**ADVISORY BOARD ON
RADIATION AND WORKER HEALTH**

**FOCUSED REVIEW ON THE CONCURRENCE OF
ORAUT-OTIB-0081, REVISION 03, AND THE DRAFT
COWORKER IMPLEMENTATION CRITERIA**

**Contract No. 211-2014-58081
SCA-TR-2017-SEC005, Revision 0**

March 2017

Figure 1. Percentage of Total Reported Bioassay Samples found in Available Logbooks (1963–1981)

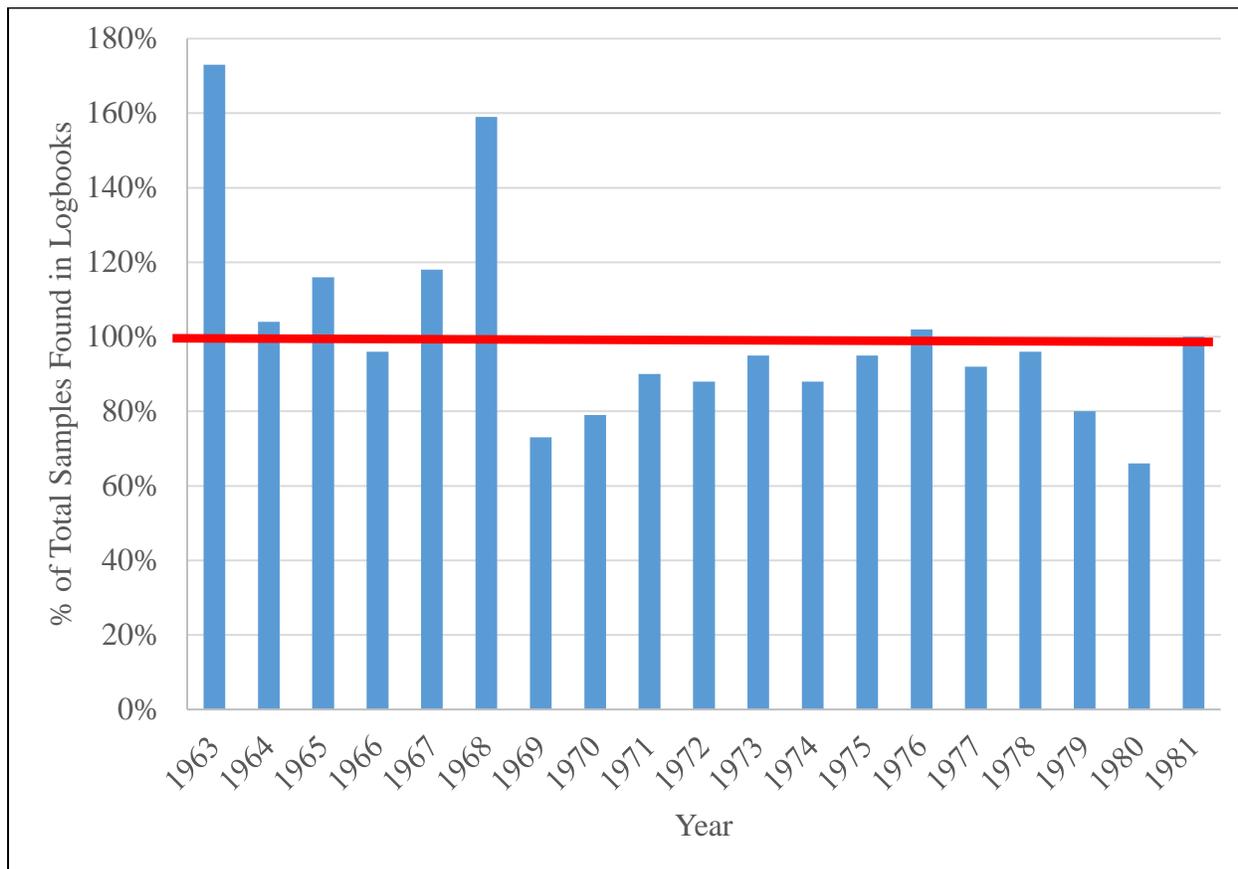
Finding 1: The analysis of the completeness of trivalent logbook records provided in NIOSH 2016a ends in 1981, though the proposed coworker analysis of trivalent bioassay extends through 1989. It would be beneficial to extend the completeness analysis to all years in which trivalent urinalysis data is being proposed for coworker evaluation. This is particularly important because the current completeness analysis suggests that the available logbook data totals are less than those reported in monthly and annual health physics summaries beginning in 1969.

As seen Figure 1 for the years 1963–1968, there were generally more samples found in the laboratory logbooks than were reported in the actual annual summaries. Beginning in 1969, there were generally fewer urinalysis samples found in the laboratory logbooks than were reported in the annual summaries. NIOSH 2016a states the following concerning discrepancies between total number of available samples and the annual summaries:

While SC&A agrees that changes between the sampling collection and analysis date can create fluctuations when trying to compare the bioassay totals, it is logical that such fluctuations would generally center around unity, with one period having a larger number of logbook results and the subsequent period having lower numbers, and vice versa. In general, the trends shown in

Table 4-1 show consistently higher numbers of logbook samples before 1969 and consistently lower numbers of logbooks samples beginning in 1969.

Figure 3. Number of Construction and Non-Construction Claimants Used in Tritium Coworker Analysis from 1954 to 1990

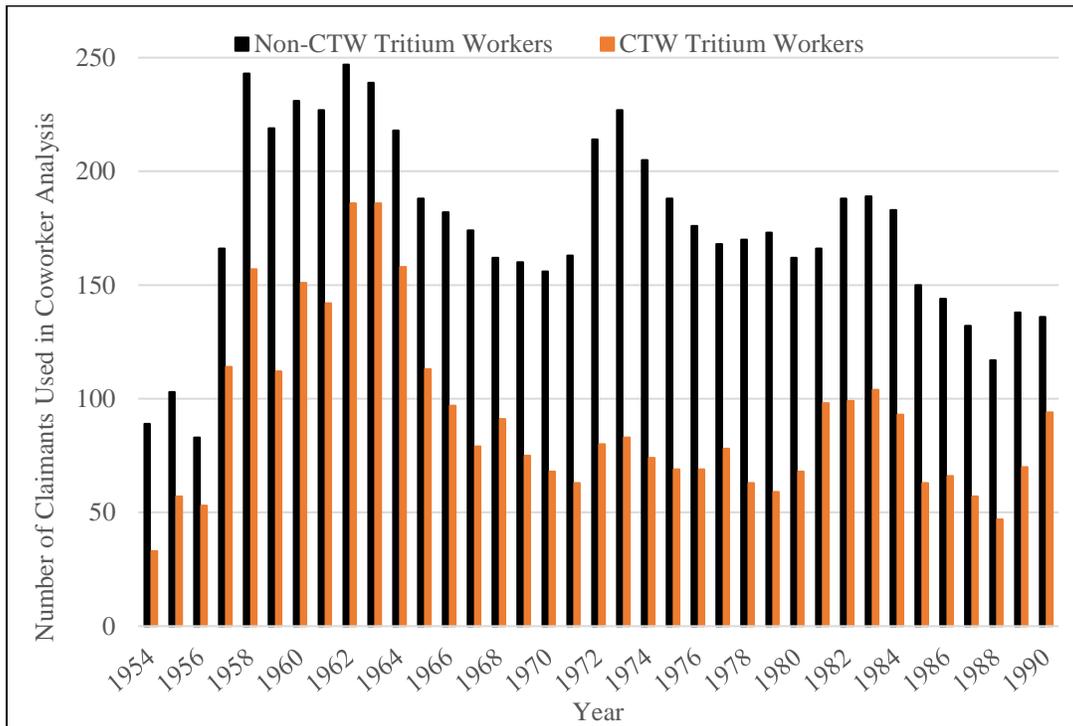
Because the tritium coworker model is based on claimant records, it is a “representative” and not a “complete” dataset. Because it is representative, it is difficult to establish records “completeness” for the purpose of evaluating its appropriateness in coworker model development.³ One method would be to compare the total number of tritium workers by year found in the claimant population to the number of sitewide workers who were monitored for tritium. For example, DuPont 1968 indicates that 1,441 individuals were monitored for tritium during that year, while the NOCTS claimant population contained 253 tritium workers during this year (~18% of the total). Unfortunately, SC&A did not locate other such tabulations of the total number of workers monitored for tritium to allow for a meaningful comparison. If such information is available (or can be made available through data capture), it would help establish that the NOCTS coworker population is representative of the SRS population for the specific case of tritium coworker dose evaluation.

Figure 4. Comparison of the Trends in Sitewide Tritium Sampling Totals to the Total Number of Tritium Workers Available in NOCTS for Coworker Analysis

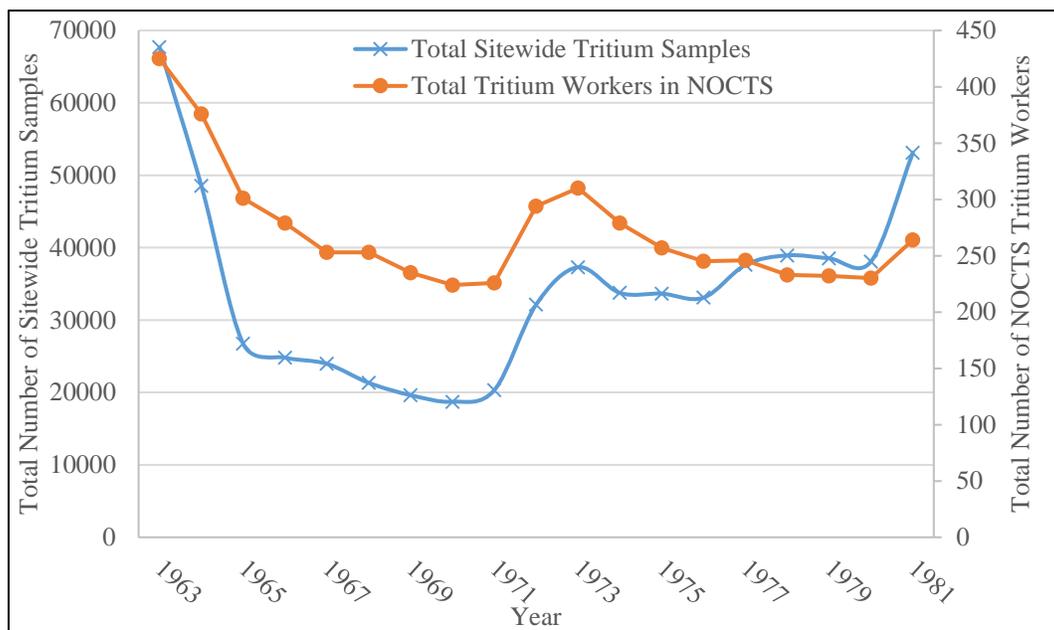
A corollary type analysis might be to compare the total number of samples by year at SRS with the total number of samples available in the claimant population. Unfortunately, at the time of this review, the total number of tritium samples used in the NIOSH 2016a analysis was not available to SC&A. However, a comparison of the total number of sitewide tritium samples to the number of NOCTS tritium workers can also provide some insight into the relative completeness of the coworker dataset by comparing the temporal trends (see Figure 4). As seen in Figure 4, the number of tritium workers in NOCTS roughly follows the trend of the total number of sitewide tritium samples by year (i.e., when the total number of sitewide tritium samples decreased, the total number of NOCTS workers also decreased). The exception is 1978, in which the number of sitewide tritium samples increased while the number of NOCTS claims with tritium data decreased.
